**AMENDMENTS TO THE DRAWINGS:**

FIG. 5

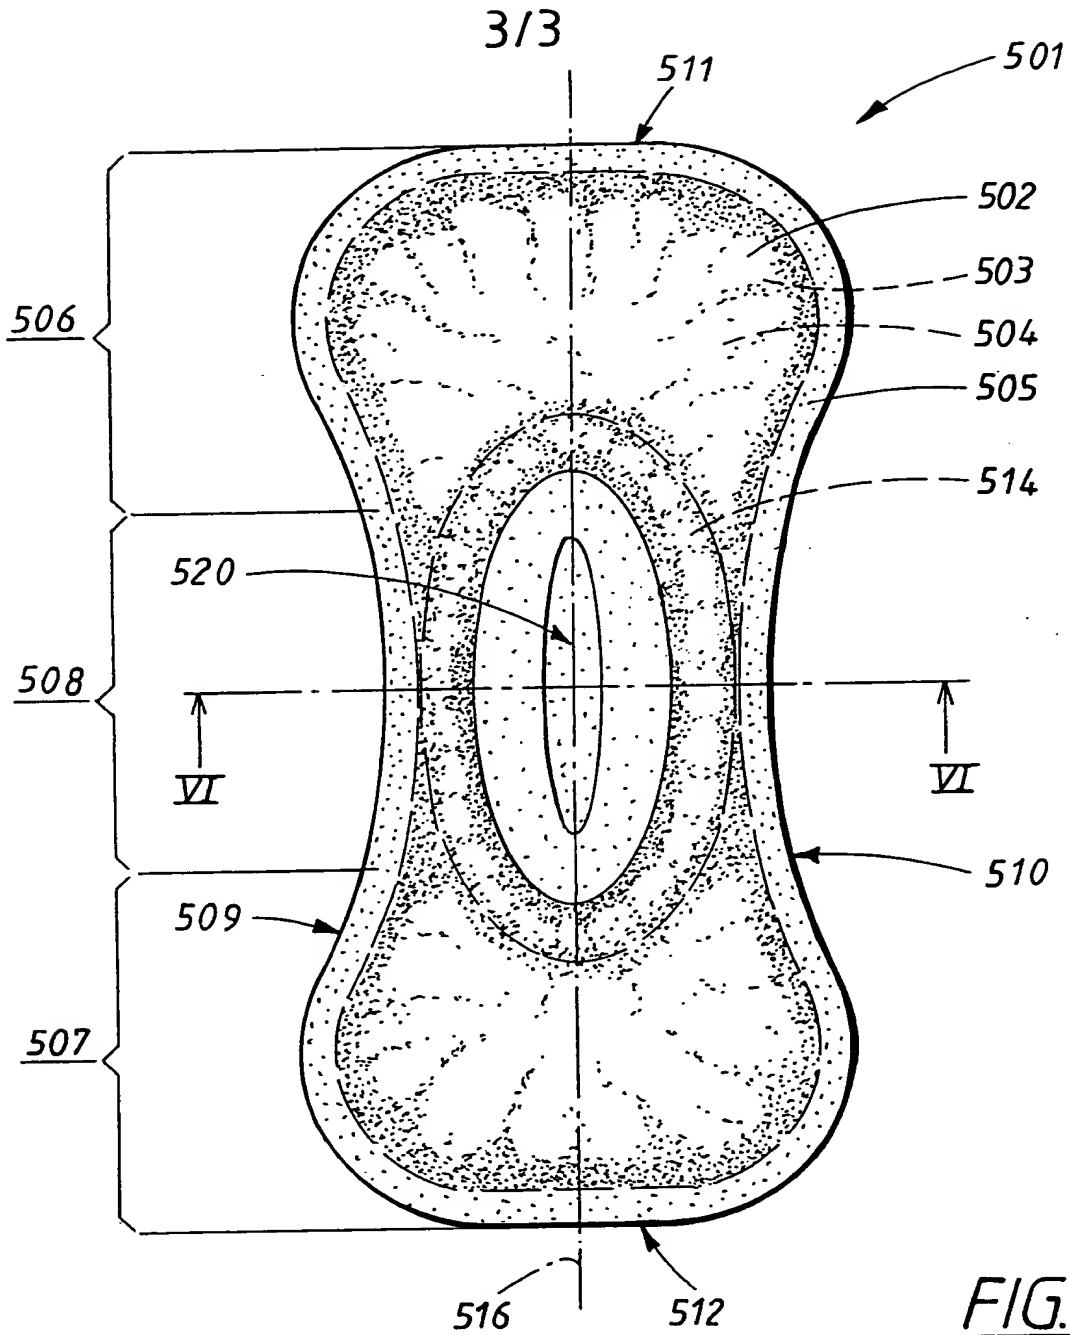
The attached sheets of drawings includes changes to Fig. 1, 2, and 5. These sheets, which include Fig. 1, 2 and 5, replace the original sheets including Fig. 1, 2, and 5. In Fig. 1, the line to reference number 125 has been expanded and an arrow has been added to reference number 113. In Figure 2, reference number 102 has been changed to indicate the liquid permeable layer and reference number 104 has been extended to indicate the absorption body. In Figure 5, reference 513 has been removed.
